TECHNICAL MEMORANDUM

January 20, 2021

Re: Oslo Bay Apartments – Critical Areas Report: Third-Party Review

Figure 1. Proposed stormwater outfall locations.

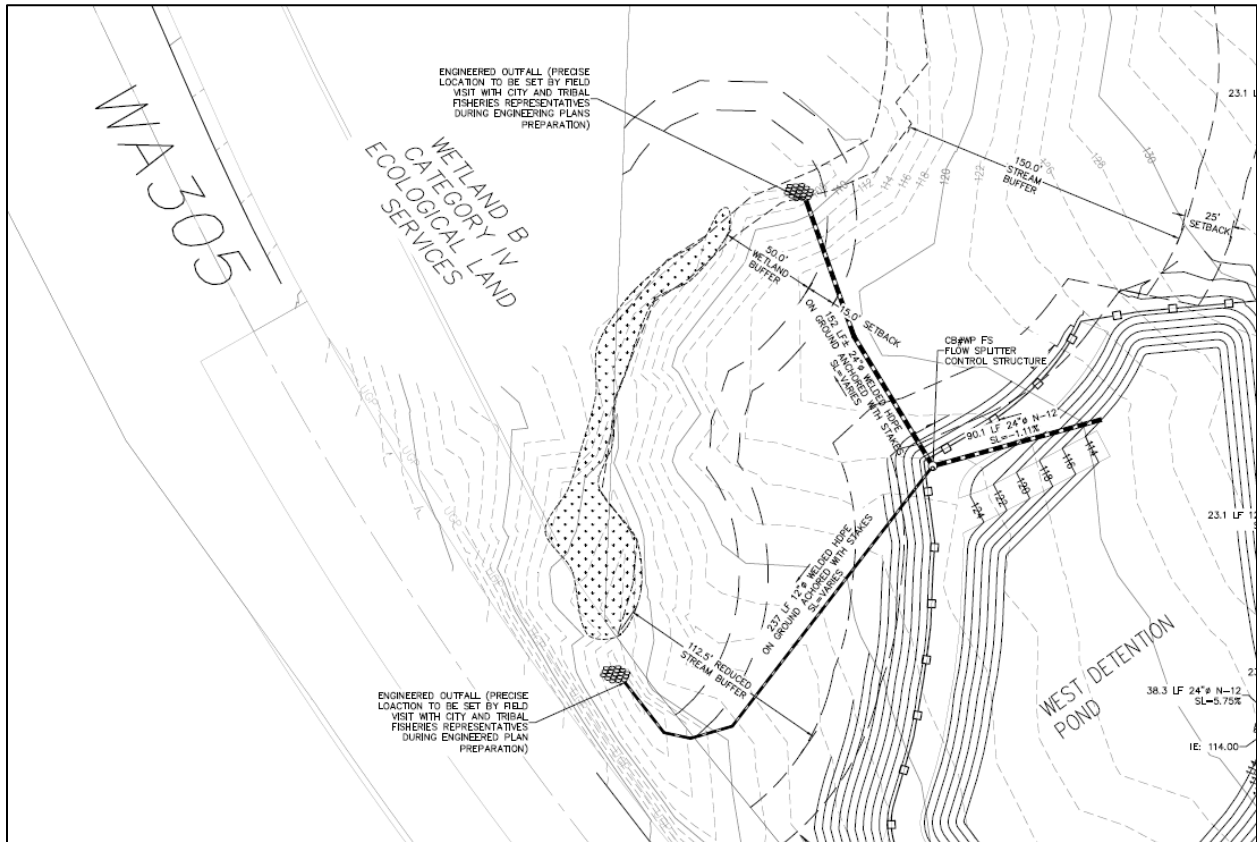
there will be no direct and/or indirect impacts that will occur as a result of the stormwater outfalls. In Grette Associates' professional opinion, the sizing of the stormwater outfall pipes (24-inches¹) suggests that there is potential for large volumes of periodic discharge from the stormwater ponds and the HMP does not provide any supporting information that the dispersion pads will be sufficient to prevent scouring and potential water quality issues. In addition, the civil plans show the larger outfall pipe associated with the western stormwater pond being constructed within the Type F2 stream (Figure 1). This is inconsistent with the description in the HMP.

- The civil plans provided to Grette Associates show the 24-inch stormwater outfall associated with the western stormwater pond extending into the Type F2 stream (Figure 1). If the civil plans show the correct location where this outfall will be constructed the HMP will need to be revised to address the direct impacts to the stream for compliance with Chapter 16.20 of the PMC;
- Per PMC 16.20.320, the proposed crossing shall not diminish flood-carrying capacity. The HMP needs to provide a brief discussion to demonstrate that the proposed culvert size will not diminish flood-carrying capacity.
